To: City of Afton Planning Commission
CC: Ron Moore, City Administrator
From: Claire Michelson, Planner
Date: January 29th, 2023
Re: Sketch Plan Review for Proposed Miller Subdivision of 46 Acres of Land with PID #s 22.028.20.22.0002 and 22.028.20.23.0006 Located Generally Between 15222 and 14960 Afton Boulevard

Miller Concept: 8 lots, 1100 feet of new road

Comments on Miller Subdivision Sketch Plan

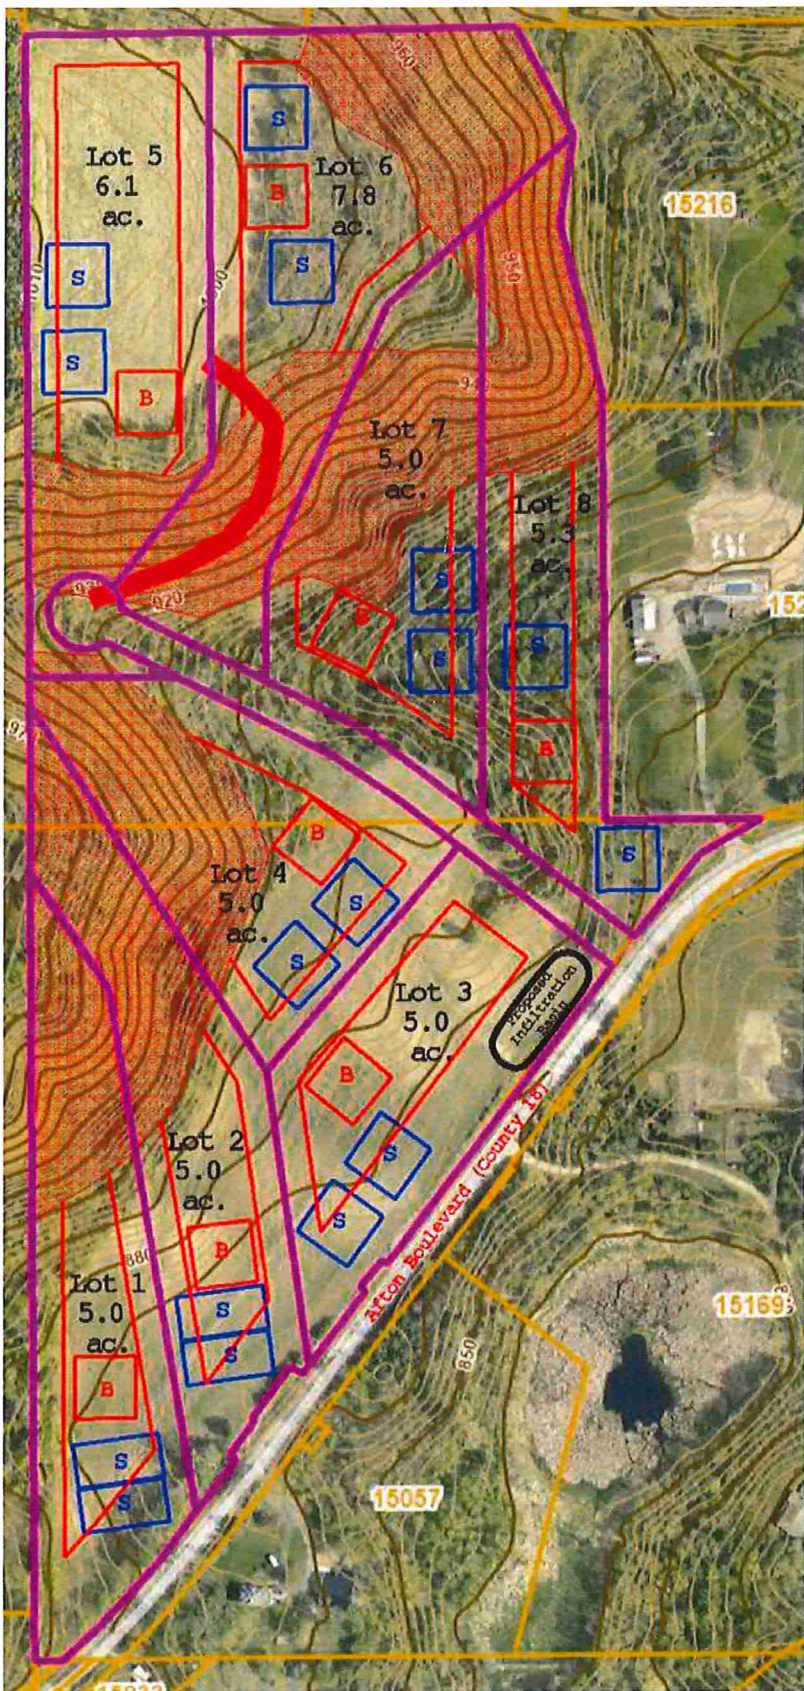
All of the lots meet the minimum lot size, road frontage/width and depth minimum requirements. There are some irregularly shaped lots. Lot 8 the frontage is the entire circular part of the proposed cul du sac, the City subdivision code (Sec. 12-1387 Lot Requirements (M)) requires that lot widths on cul du sac lots shall be no less than 300 feet at the building setback line, and it appears that Lot 8's building setback line is less than 300 feet. Lots 1-3 along Afton Boulevard are not at right angles to the street lines as required in Section 12-1387 Subdivision (A).

The concept as presented would require road construction for this subdivision. This would be a proposed 1,100 foot cul de sac road from Afton Boulevard.

The purpose of this section of the code is that it is important to plan for a network of through-roads where possible, and that when it would make sense from a long term road planning perspective to plan for a through-road at the end of a cul de sac, the cul de sac should be built to the boundary of the property being subdivided, or a road right-of-way should be dedicated to the property line, so that the possibility of a future through-road would not be lost. This assumes there are no other barriers to building a through-road, such as the adjacent subdivision having a covenant against access from a new subdivision or a topographic barrier such as steep slopes. As shown on the sketch plan, if the road were to be extended to the westerly property there are steep slopes above 18% where the city code prohibits development on slopes steeper than 18% making it difficult to build and extend the proposed road.

The concept plan shows a stormwater infiltration pond at the intersection of the cul de sac road and Afton Boulevard to manage the additional stormwater run-off to be created by the cul de sac road. Depending on the run-off volumes for individual homes, they may require additional stormwater facilities with rain gardens.

Washington County provided comments on the sketch plan in the attached letter, and is requesting that in the preliminary plat the plan include the dedication of additional public right-of-way sufficient to provide a total right-of-way width of 120 feet for this portion of Afton Boulevard (CSAH 18) as identified in the Washington County 2040 Comprehensive Plan.

Lots 1 and 2 driveways would be accessed from Afton Boulevard (County 18). Lots 3-8 would be accessed from the proposed cul de sac road. Due to the steep slopes on the northern part of the property lots 7 and 8 are proposed to be accessed from a shared driveway. Staff would like to note that shared driveways are only allowed in the city code if they serve lots of 20 acres or more.

Washington County, as reflected in its attached letter, does not support the proposed access points onto Afton Boulevard (CSAH 18). The County limits the placement of access points to county roads to minimize conflict points and improve highway safety. The current proposal does not adequately limit access points onto the county road and the proposed street (cul de sac) is in an area with constrained sight distance due to the curve in the road. Access permits will be needed to construct new street connections within the county right of way.

The land has two tiers separated by a steep slope. Lots 1-4 and 7-8 are located on the lower tier. Lots 5 and 6 on the upper tier. There is a significant slope on the upper area, and the Zoning Code does not allow the construction of a driveway that crosses an area with a slope of 18% or greater. Lots 5 and 6 would be accessed using an existing legally nonconforming field road that has an average slope of 10.7% and crosses an area with slopes greater than 18%.

Approximately 29 acres of the property are currently wooded. Of those 29 acres, approximately 14 acres are steeper than 18%. The buildable area for lots 1-5 is open non-wooded areas that would require minimal tree clearing. The buildable area for lots 6-8 is in wooded areas and clearing would be needed for construction of houses, garages, septic systems and driveways. The anticipated clearing area is about .75 acres and approximately 1 acre of clearing for construction of the proposed cul du sac road. The total amount of clearing equals approximately 3.25 acres which is 11% of the wooded area. The proposed clearing appears to adhere to the city tree protection and reforestation ordinance as it is under the 30% maximum.

- It was indicated it is important to minimize the removal of trees, and asked if a tree inventory was required. Staff indicated that, because the vast majority of trees will be undisturbed, a full tree inventory is not needed, but it would be helpful to have a tree inventory of those trees 6 inches or greater in diameter in the area that will be disturbed for the cul de sac road and in the wooded areas that will be disturbed for houses. This would particularly be helpful in identifying large trees that could be saved by routing the road around them or by being flexible with the driveway and house locations.

- The shared driveways are currently allowed only to serve lots that are 20 acres or larger.
- It was pointed out that there are some irregularly shaped lots, particularly the small portion of the lot that curves around the end of the cul de sac to provide the required 300 feet of frontage, and the lot lines along Afton Boulevard not being at a 90-degree angle to the road.

- It was suggested that the slope of the historic farm road that is proposed to serve two lots should be confirmed.

CSAH 18 is currently classified as an "A-Minor Connector" roadway. The Washington County 2040 Comprehensive Plan contains access criteria for county roads related to spacing, sight lines, and availability of local road connections. CSAH 18 requires preserving 120 feet of right-of-way for this portion of CSAH 18. The site sketch does not indicate any dedication of right-of-way along the parcel, and does not meet the needs identified in the Comprehensive Plan. The applicant will be required to update the plan to show a dedication of right-of-way along the parcel.

With respect to spacing, collector roads are guided for full-access intersections at a minimum spacing of 1/4 mile (1,320 feet). Washington County is dedicated to the pursuit of access management practices to maintain the intended balance of access and mobility on county roadways; therefore, Washington County does not support the proposed access points proposed onto CSAH 18. The proposal shows a proposed public street and two driveway access points with minimal spacing between each access points. The County limits the placement of access points to county roads to minimize conflict points and improve highway safety. The subdivision proposal does not limit access points onto the county road and the proposed public street is located in area with constrained sight distance due to the curve. The County recommends that the City work with the developer and limit the development to one access point and ensure that each lot is accessed off the proposed public street. Access permits will be needed to construct new street connections within the county right-of-way.
